# Access Compliance Report Public Rights-of-Way (Curb Ramps)

Main Street: CARLSBAD\_DR Cross Street: LEAFWOOD\_LN Location: NE

ADA ID: RPAT211019111148 Ramp Type: Type 1 - Perpendicular Diagonal Initial Pass/Fail: Fail Overall Compliance: No Severity Score: 2

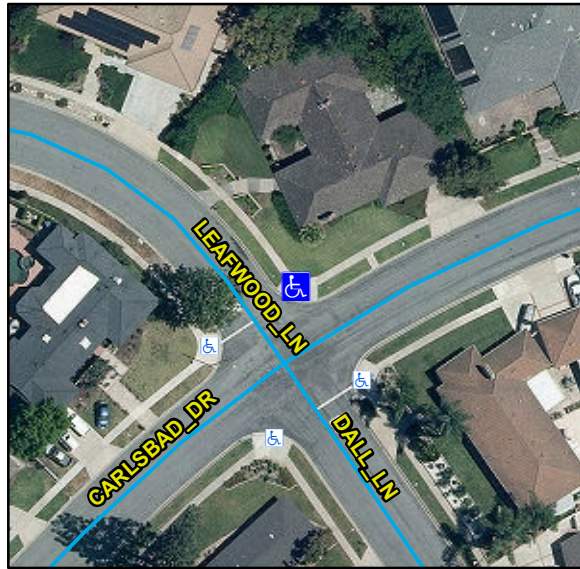
| Compliance | Description                           | Data | Compliance | Description                   | Data |
|------------|---------------------------------------|------|------------|-------------------------------|------|
| No         | Ramp Cross Slope (%)                  | 2.4  | N/A        | Flare Traversable LT          | N/A  |

Remove & Replace Curb Ramp With Two New Directional Ramps or Equivalent.
